MICHIGAN
STATE HIGHWAY DEPARTMENT
JOHN C. MACKIE, COMMISSIONER

Subject: Rustake Glare-Proof Fencing. Research Project 61 NM-58.
Research Laboratory Report No. 380.

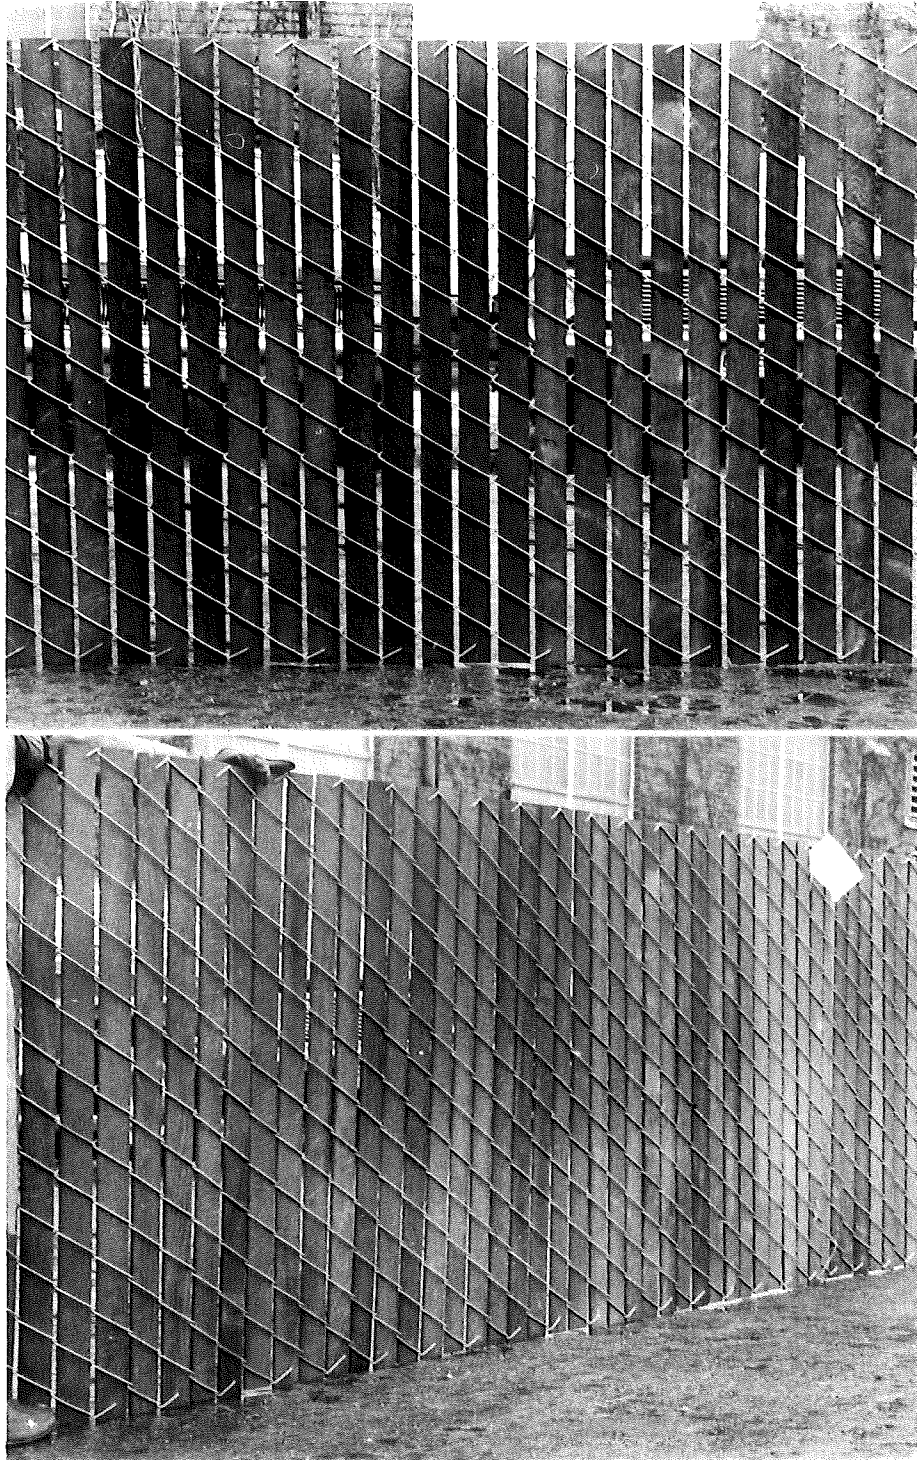
The sample is shown in Fig. 1. The fence is 4 ft high and consists of cedar or redwood slats wired together at 0.5-in. intervals. The slats are 2.5-in. wide and 3/8 in. thick.

Measured against these criteria, Rustake fencing is not a suitable glare screen. While it effectively obscures glare from oncoming headlights, it permits practically no lateral visibility and by its construction would act as an almost perfect snow fence to cause drifting on the roadway. It is also questionable whether the esthetic appearance would be acceptable.

For the above reasons, the use of Rustake fencing as a glare screen is not recommended.

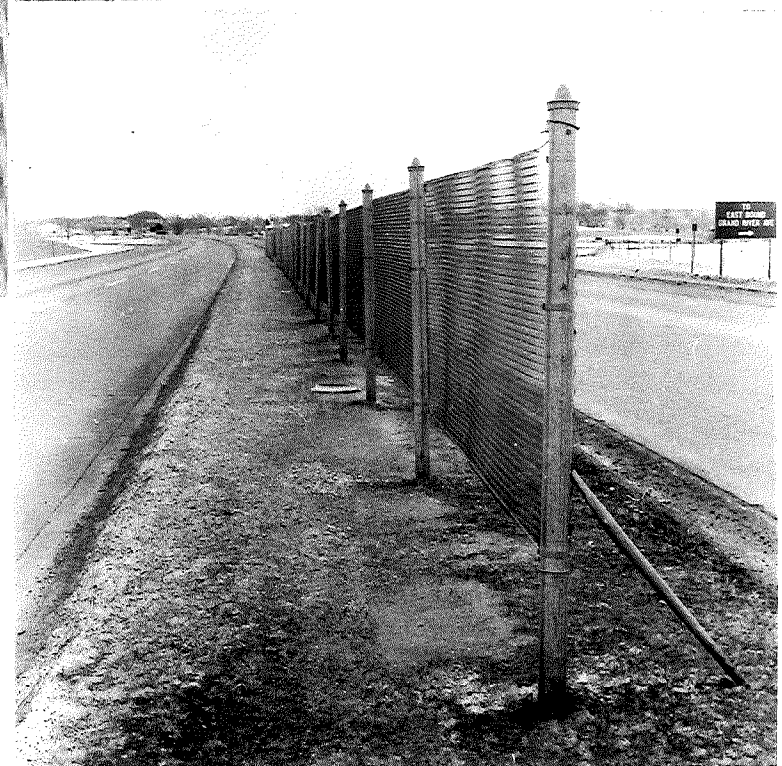
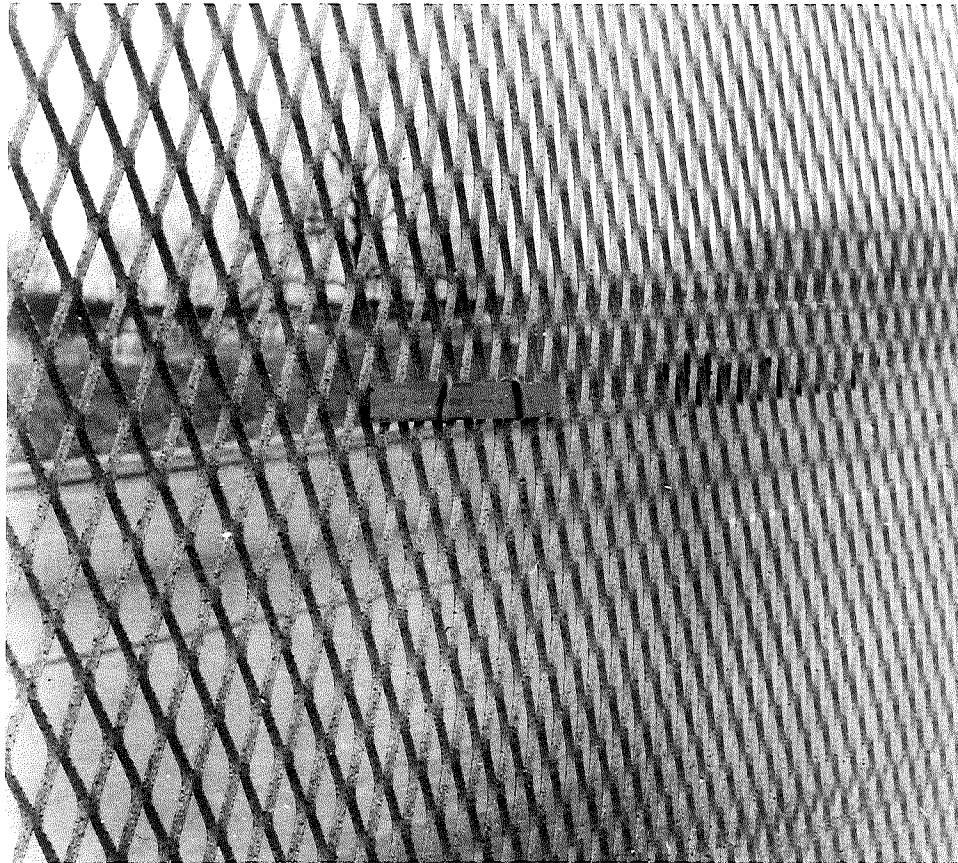
For comparison an inspection was made of the field installation of Alcoa glare screen on I 96 east of Brighton (Fig. 2). The design of this screen appears to provide

minimum obstruction of air currents (with consequent minimum snow fence action) consistent with affording maximum optical interception of glare from approaching vehicles. The figure illustrates how visibility through the fence drops off at greater distances ahead, yet appears to be adequate at closer distances.
